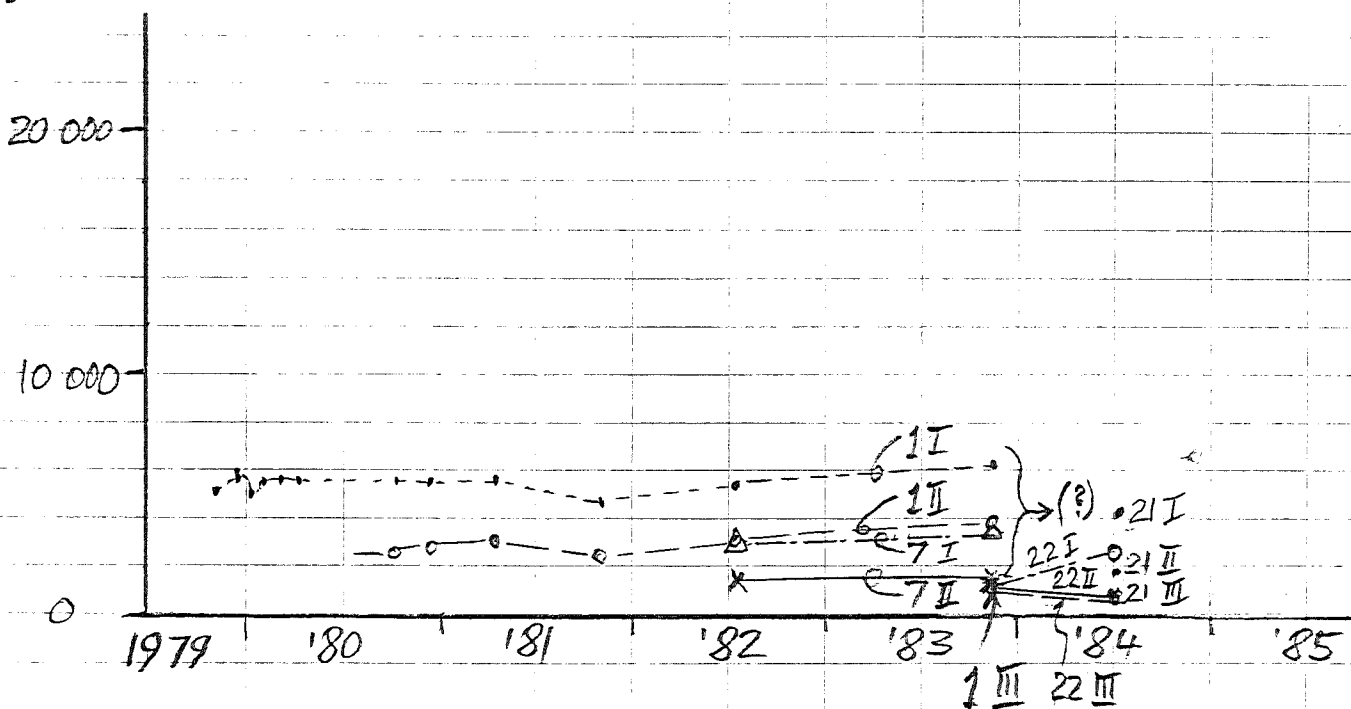
However, the monitoring data, if not totally dismissed,
indicate the presence and progression of a leachate plume
(...2)

in agreement with the direction of the measured pressure profiles (which are not in question)

We request:

1. Completion of a credible Water Balance for the present regional landfill
2. Sufficient leachate analyses of samples from the mid-depth wells as well as from the collection system to prove the completion of electrical neutrality.
3. Evaluation of the analyses of well samples (monitoring reports) and their concentration changes with time for plotting the progress of the concentration changes.
4. Review of piezometer well data and plotting of pressure profiles as they may have changed with time
5. Installation of two additional monitoring wells in the predominant down-hill direction from the oldest part of the landfill, i.e. near the entrance road from N. Service Rd. to the weigh scale.
